# C_comp in IBIS

Walter Katz

IBIS-ATM June 9, 2015

IBIS 6.0 page 32:

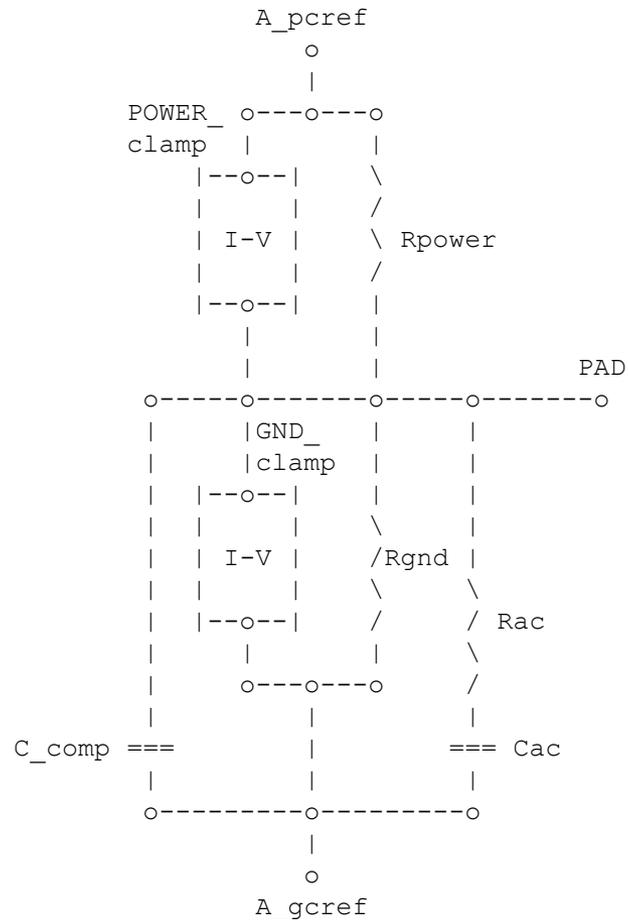
IBIS Describes How to Hook Up C_comp_* When Simulating
